Beomaster 7000

Beomaster 6500

Corrections

10-91 3538794 Indklæbes i Serviceanvisningen Beomaster 6500 (3538751)
Paste into Service Manual Beomaster 6500 (3538751)
In Serviceanleitung Beomaster 6500 (3538752) einkleben
A coller le Manuel d'entretien pour Beomaster 6500 (3538752)

DIAGRAM C MICROCOMPUTER, IR TRANSCEIVER, DISPLAY

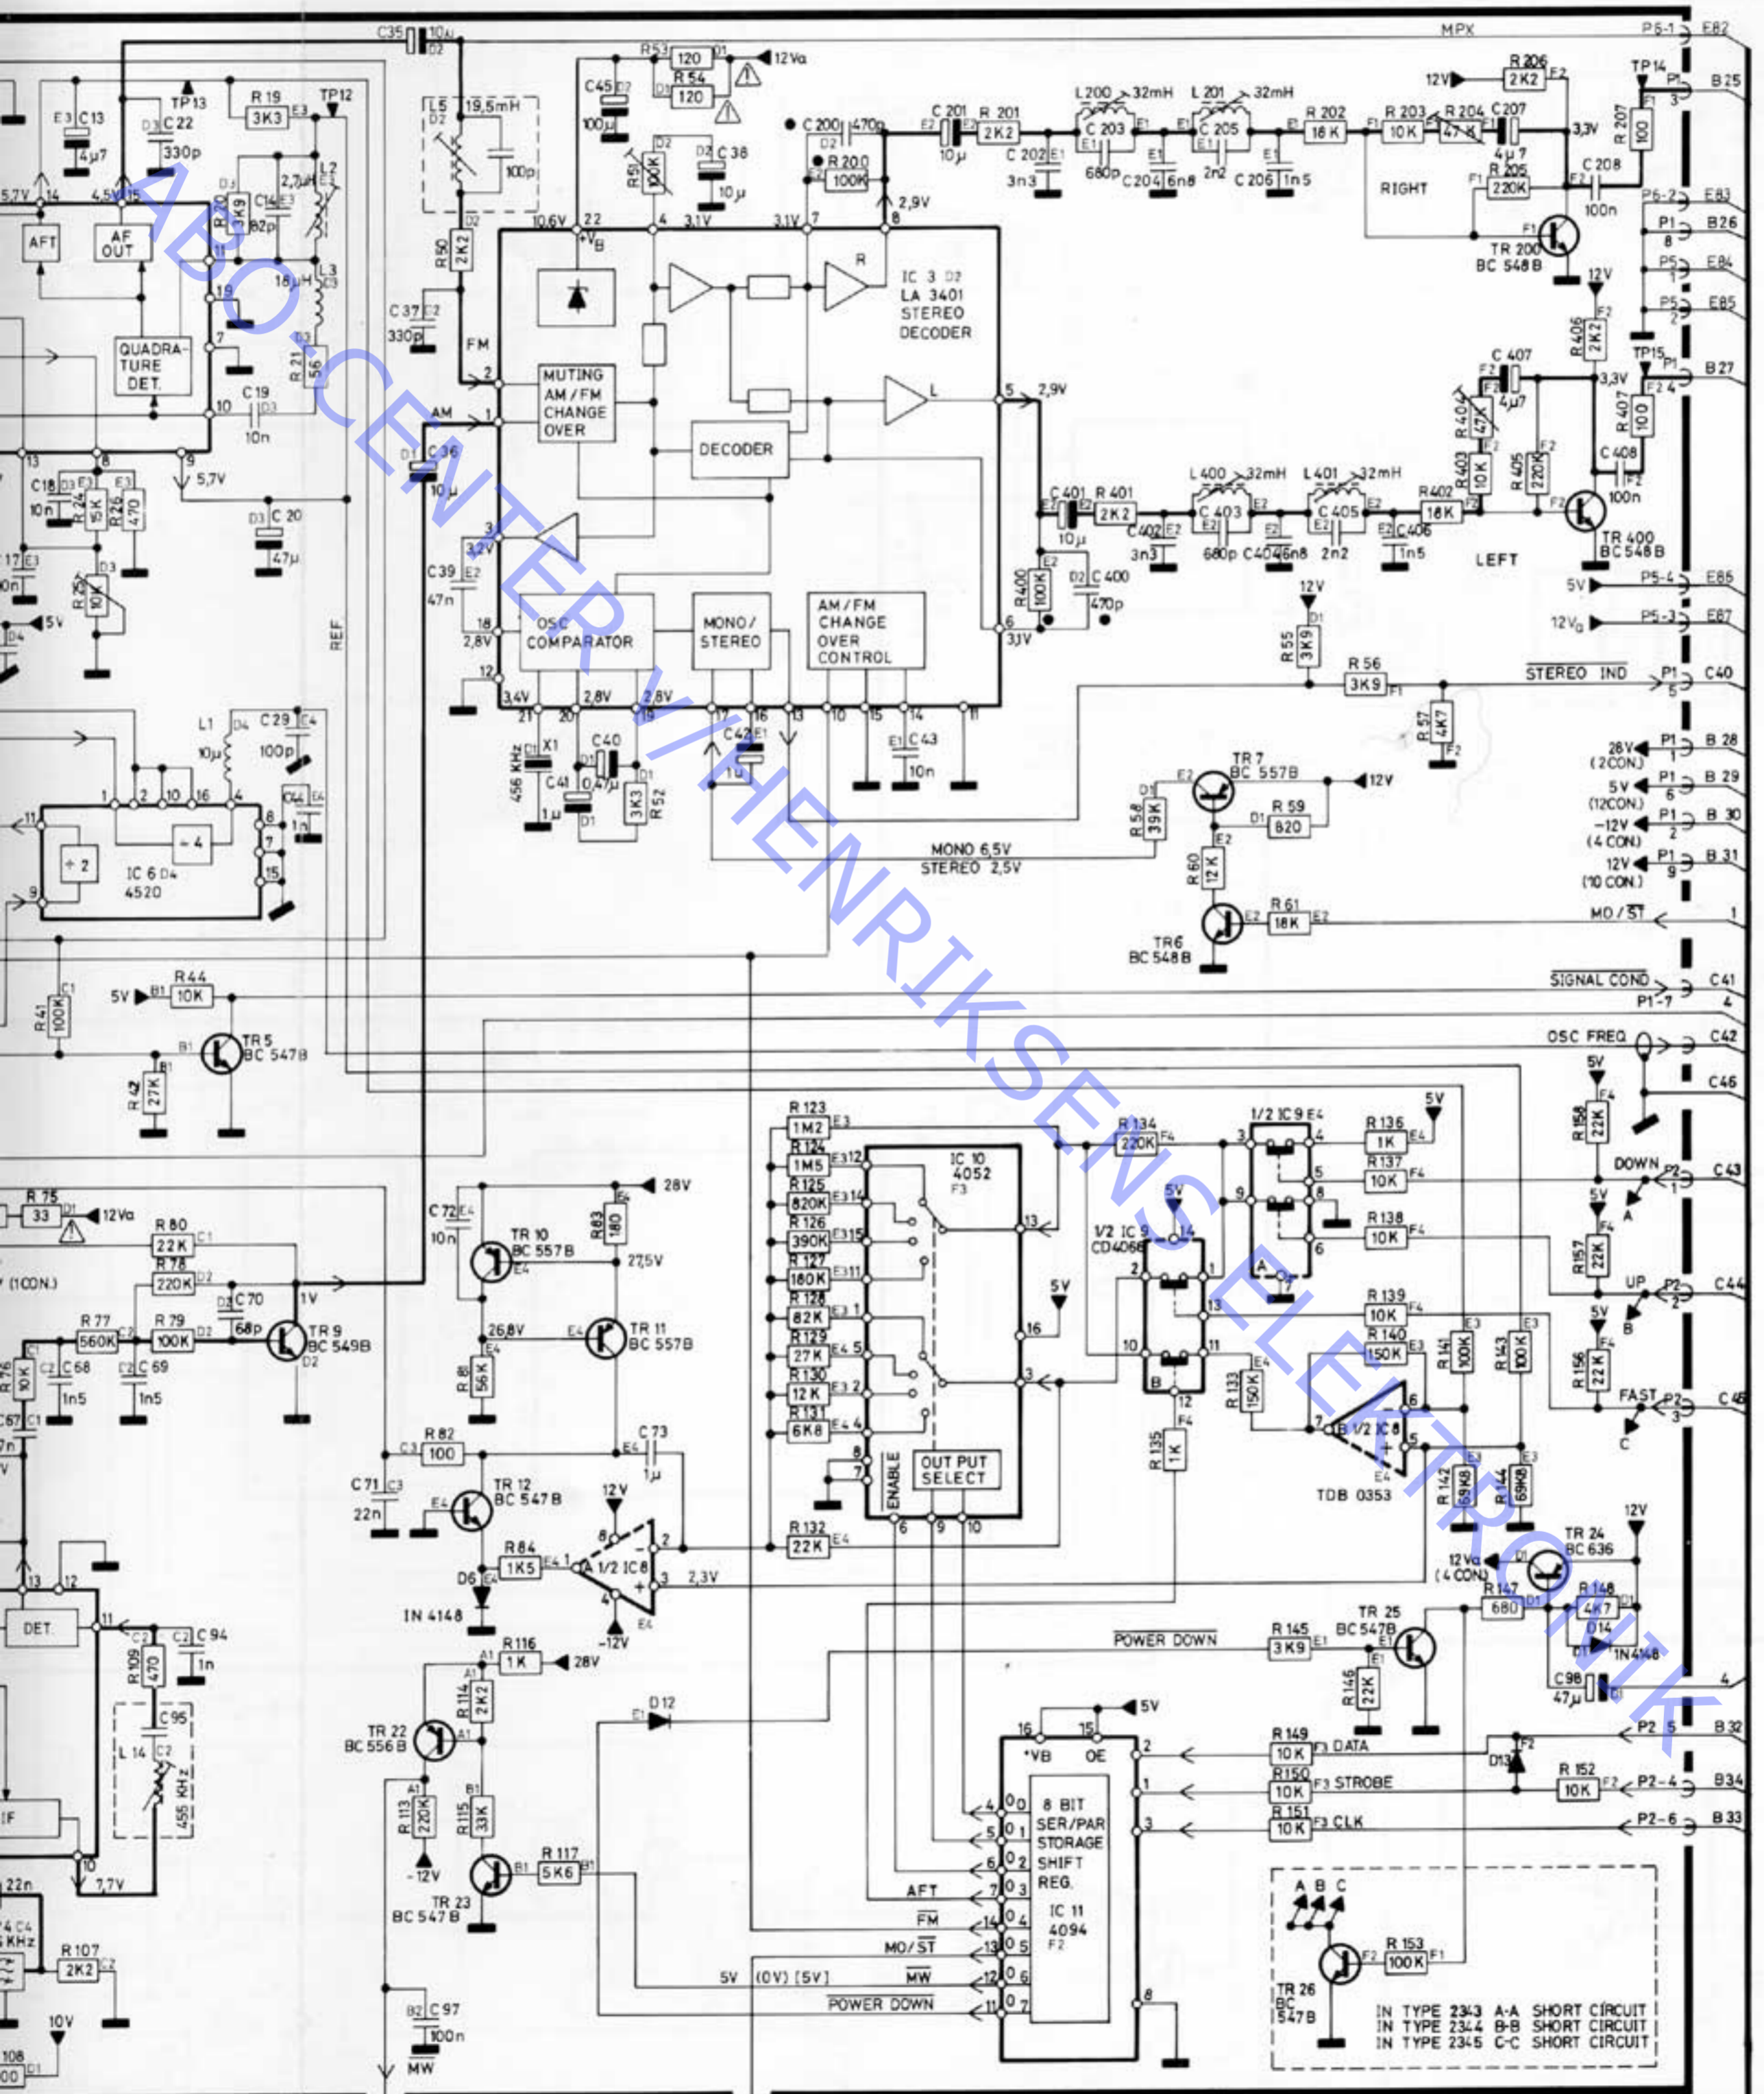
Connection to pin 7 (TEST) on 4IC2 is deleted.

The value of 4X1 is 11.0592MHz.

Part no. on 4IC1* must be 8341069

Part no. on 4IC4* must be 8341309

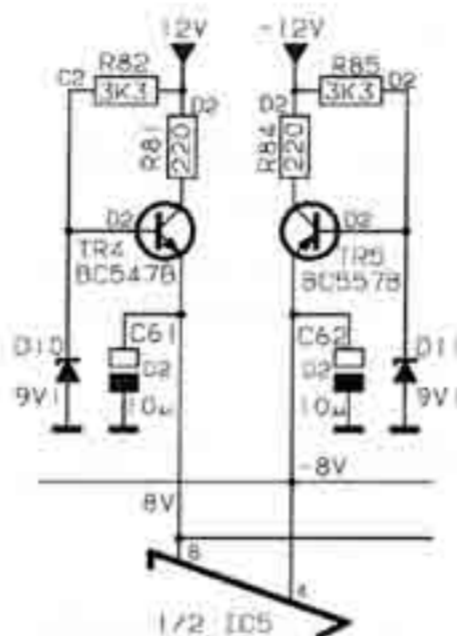
An kondensator part no. 4200510 10μ 20% 16V has been added to the collector on 2TR16.

3R81 and 3R84 5010092 220Ω 5% 1/4W has been added:

7TR2 BC338 is an NPN transistor. Emitter to the ground.
